REPORT ON
REST AREA WATER SYSTEMS
For
Interstate Highways

Iowa State Highway Commission

Robert L. Johnson, P.E.
Sanitary Engineering Consultant
Ames, Iowa

Date: November 15, 1967

BASIC WATER SYSTEMS

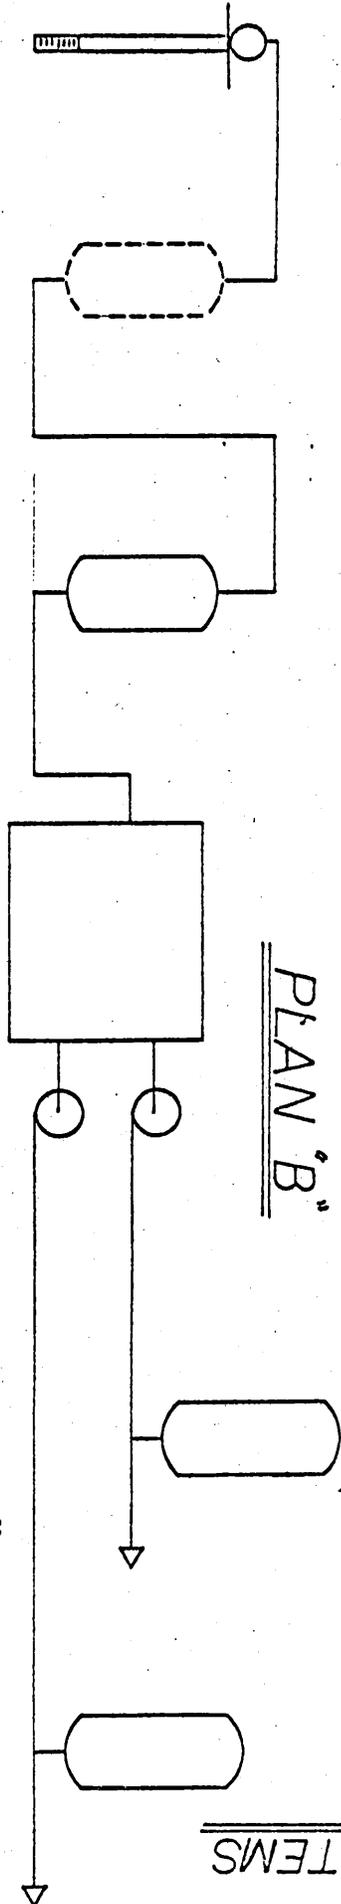
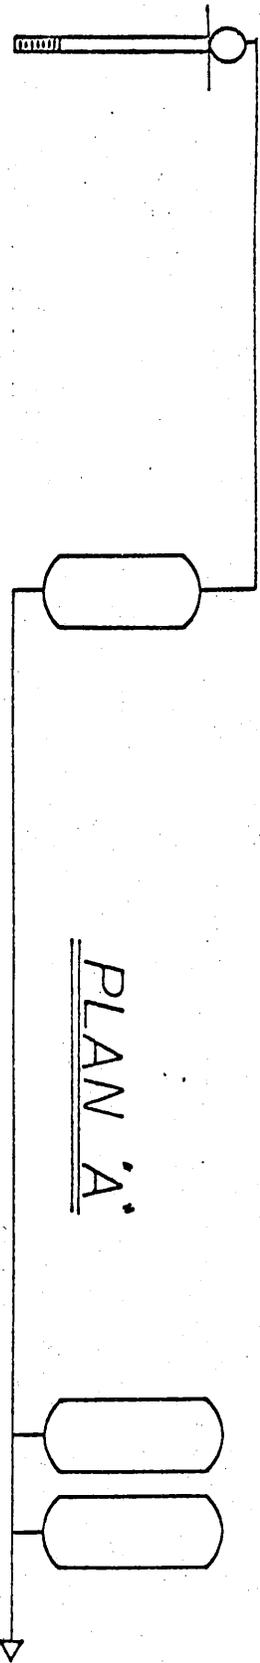
At this point, there are really only two basic plans, Plan A and Plan B, since Plan AA is only a special case of Plan B where iron and manganese removal is not required. These two plans will cover quite a wide variety of possible well capacities and water qualities. The advantages and disadvantages of these plans are summarized below. The plans are shown schematically in Figure 1.
